Access Compliance Report Public Rights-of-Way (Curb Ramps)

Main Street: GILBERT_ST Cross Street: CERRITOS_AVE Location: NE

ADA ID: RPAT211122121013 Ramp Type: Type 4 - Parallel Initial Pass/Fail: Fail Overall Compliance: No Severity Score: 15

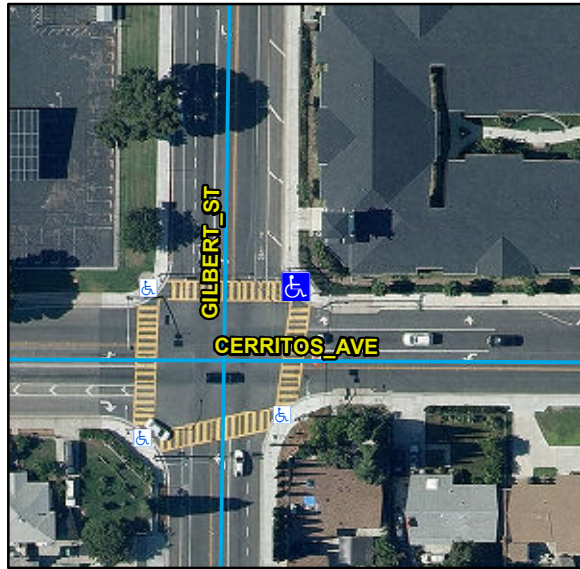
Compliance	Description	Data	Compliance	Description	Data
N/A	Ramp Length LT (in)	106	N/A	Ramp Length RT (in)	102
Yes	Ramp Width LT (in)	101	Yes	Ramp Width RT (in)	90
Yes	Ramp Run Slope LT (%)	7.8	No	Ramp Run Slope RT (%)	8.6
Yes	Ramp Cross Slope LT (%)	0.1	Yes	Ramp Cross Slope RT (%)	1.2
N/A	Landing Present	N/A	N/A	DWS Provided	N/A
N/A	Landing Length (in)	N/A	N/A	DWS Contrast	N/A
N/A	Landing Width (in)	N/A	N/A	DWS Length (in)	N/A
N/A	Landing Run Slope (%)	N/A	N/A	DWS Full Width	N/A
N/A	Landing Cross Slope (%)	N/A		DWS Offset Type	N/A
N/A	Landing Movement Obstructed?	N/A	N/A	DWS Offset Left (in)	N/A
	Landing Movement Type	N/A	N/A	DWS Offset Right (in)	N/A
N/A	Landing Shared	N/A			
N/A	Clear Space	Yes			
N/A	Clear Space To Crosswalk (in)	48			
N/A	Marked Crosswalk 1	Yes	N/A	Marked Crosswalk 2	Yes
	Crossing 1 Direction	W		Crossing 2 Direction	S
	Marked Crosswalk 1 Width (in)	150		Marked Crosswalk 2 Width (in)	150

Remove & Replace Curb Ramp With Two New Directional Ramps or Equivalent.

R304.3.2, STD 1115
